Re: Meineke Car Care 5901 Carmel Dr NE

Request for Certificate of Occupancy- 30 Day Temp Transportation Development Final Inspection Architect's Stamp dated 9-22-20 (C18D049)

Based upon the information provided in your submittal received 12-6-23, Transportation Development has no objection to a <u>30-Day Temporary Certificate of Occupancy</u>. This letter serves as a "green tag" from Transportation Development for a <u>30-Day Temporary Certificate of Occupancy</u> to be issued by the Building and Safety Division.

TRAFFIC CIRCULATION LAYOUT APPROVED 01/06/2022

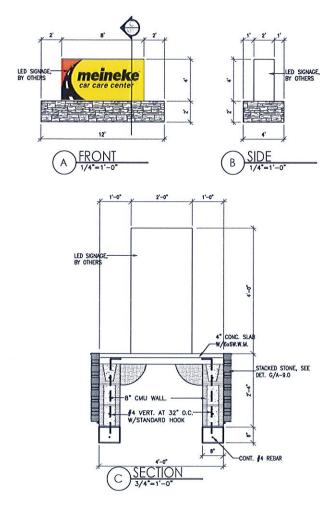
- 1. The sidewalk connection to the San Pedro ROW is to be built as this is the ADA pathway for the site as shown on the approved plan.

2. Provide three bicycle parking spaces. Currently, there is one wave-style rack, which offers the possibility of providing two bicycle spaces. However, users may attempt to park perpendicular to a wave style rack as this is the intention of the manufacturer. The type of bike rack and the layout of the racks shown on the approved plan is a better style bike rack/layout as there is no confusion on its use.
